Sheet Description:
HVAC / VENTILATION PLAN
 Project Information:
FOX RUN DEVELOPMENT
 N49W6337 WESTERN ROAD
 CEDARBURG, WI. 53012

Plan Review No.: CB-042300284-PRHVAC
Application No.: DIS-032310594
Site ID No.: SIT-105224

Jennifer Zettler
Commercial Building Plan Reviewer
Division of Industry Services
Phone: 608-781-0524
Email: jennifer.zettler@wisconsin.gov

HVAC DUCTWORK LAYOUT
 LOWER LEVEL SOUTH
 3/32" = 1'-0"

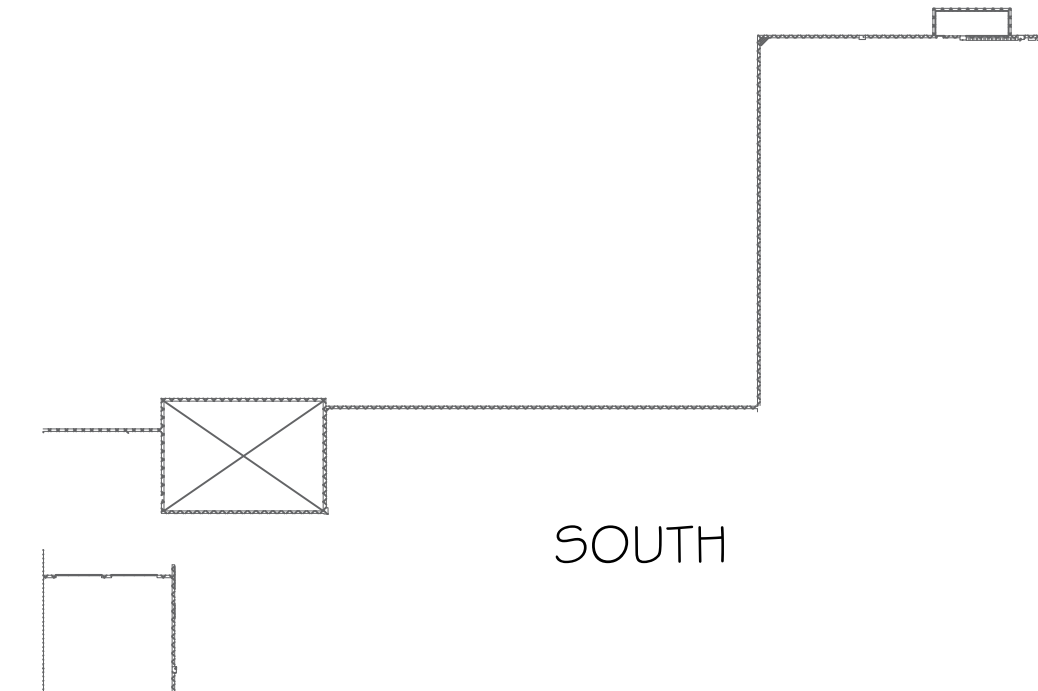
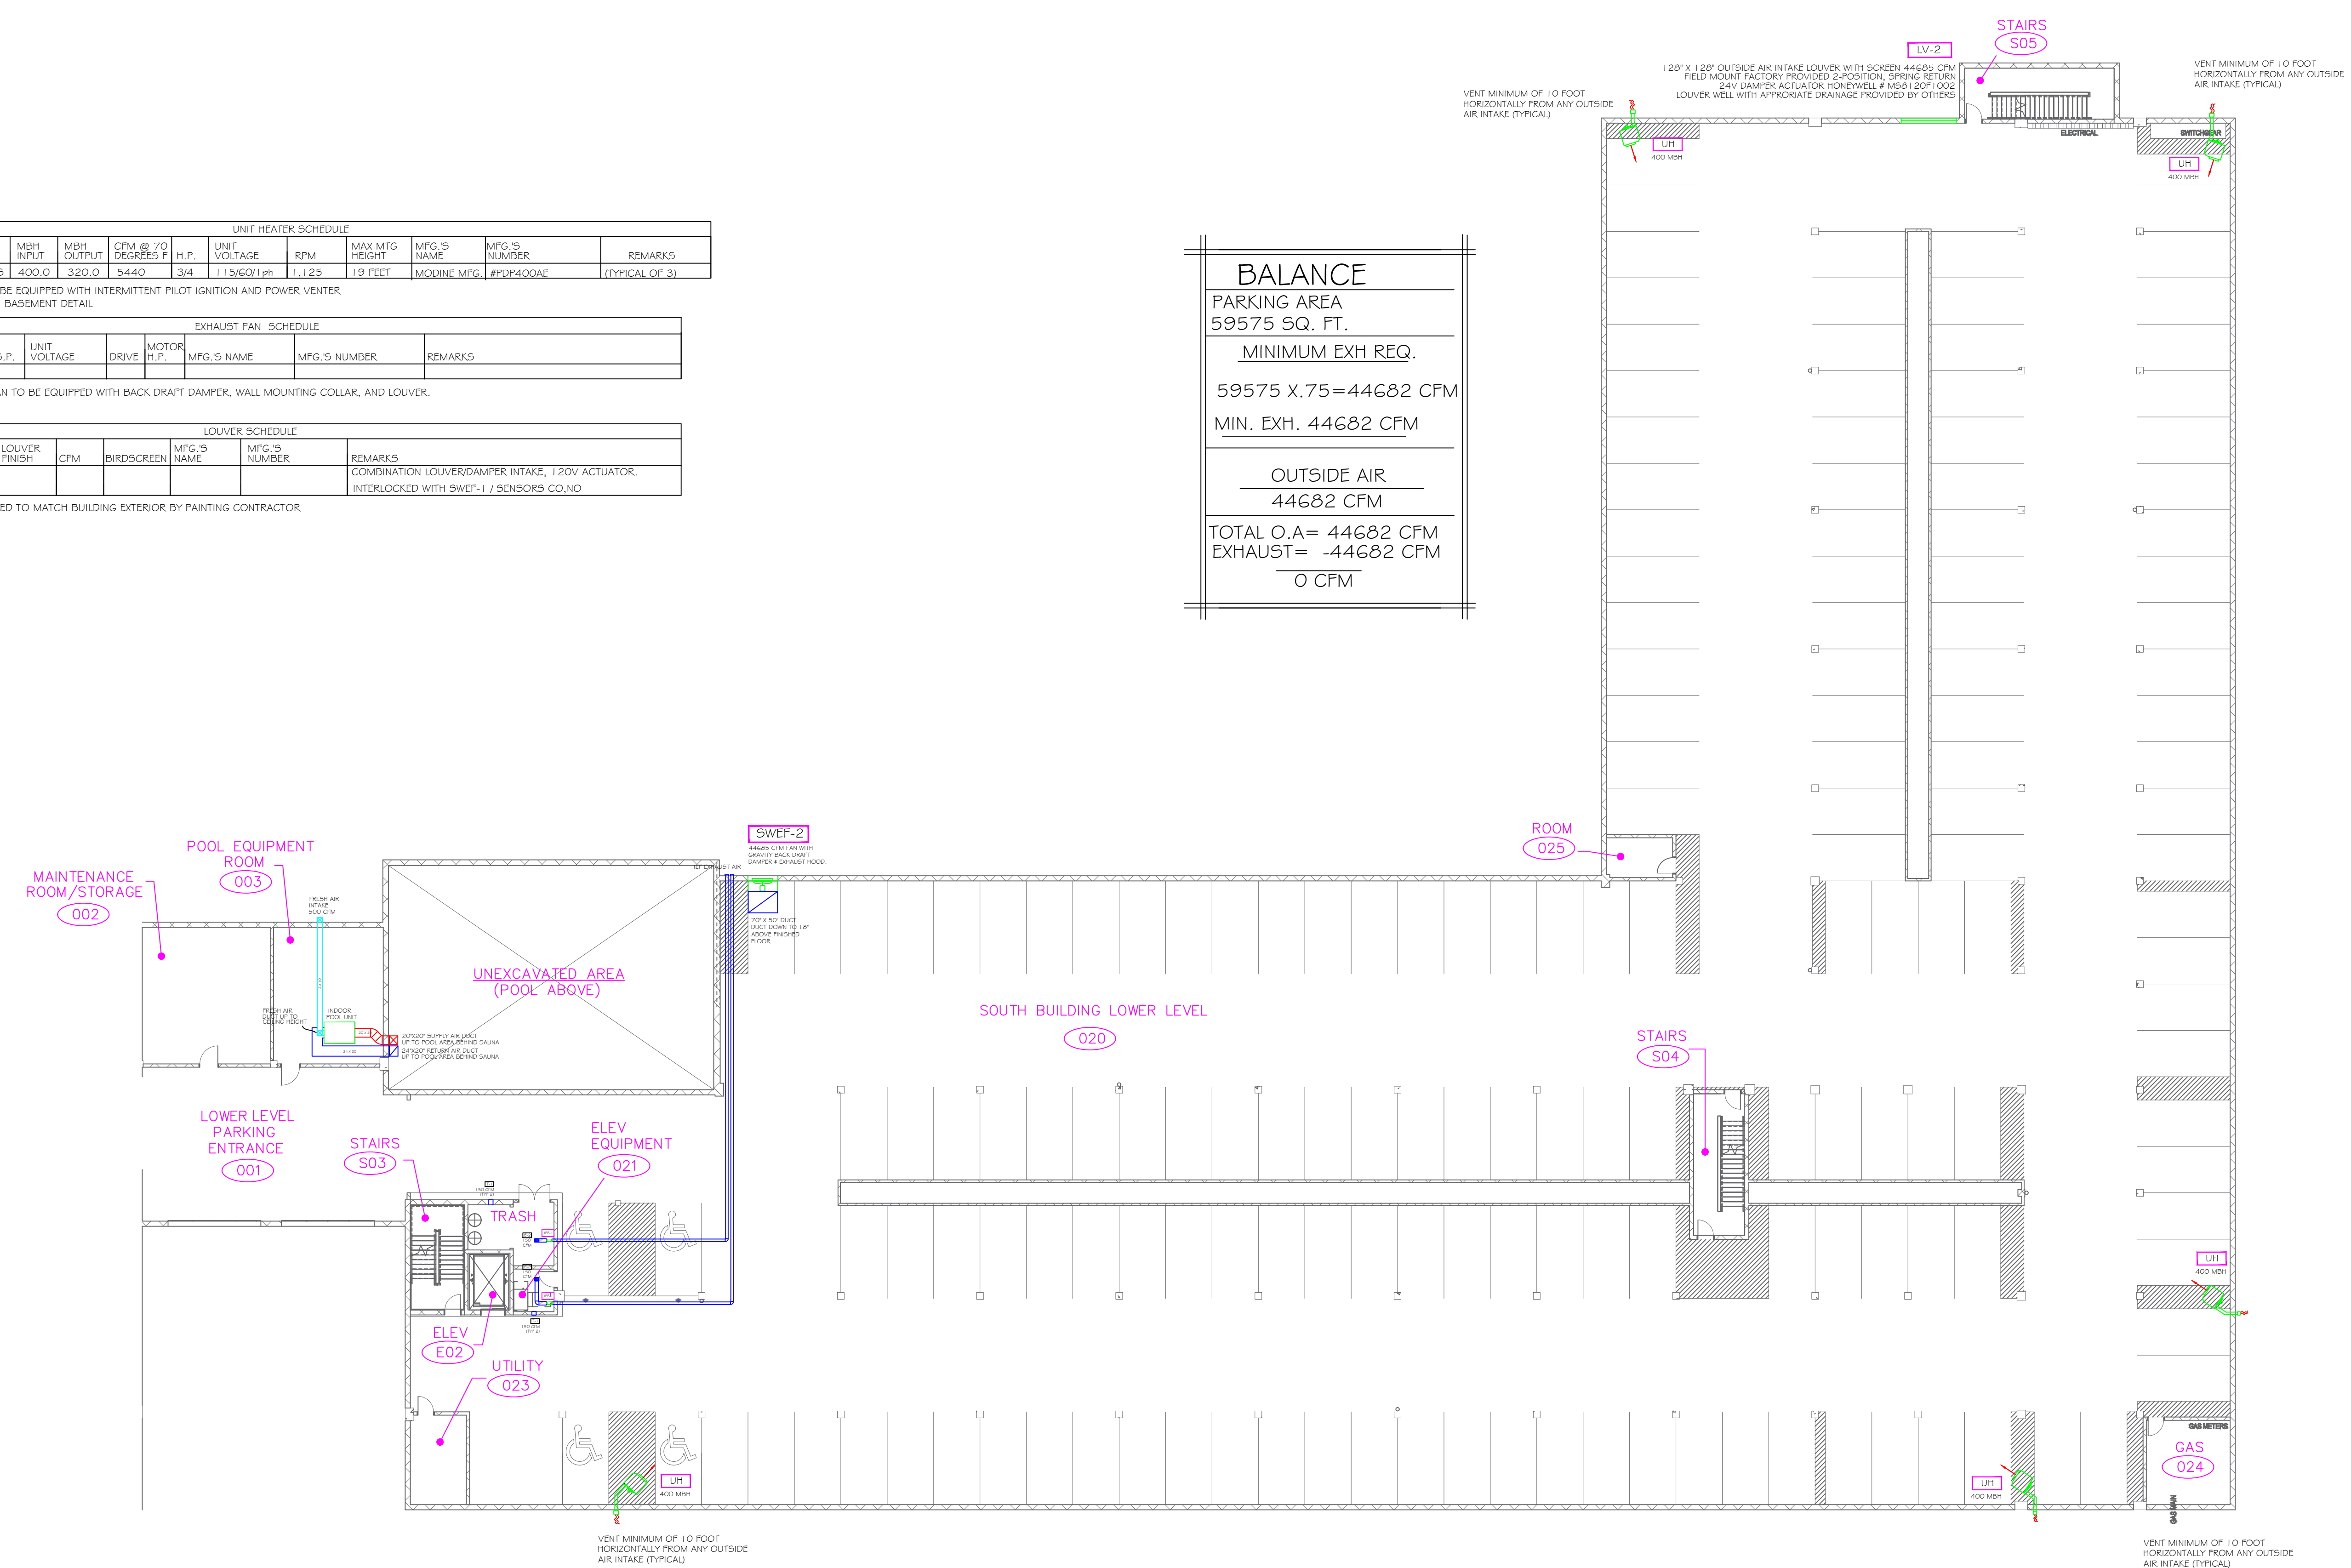
- SPS 364.0401 / IMC 404.1 Plans note utilization of exception to the requirement to continuously exhaust garage.
- IMC 403.1 - Provide an amount of supply air which is approximately equal to the amount of return and exhaust air.
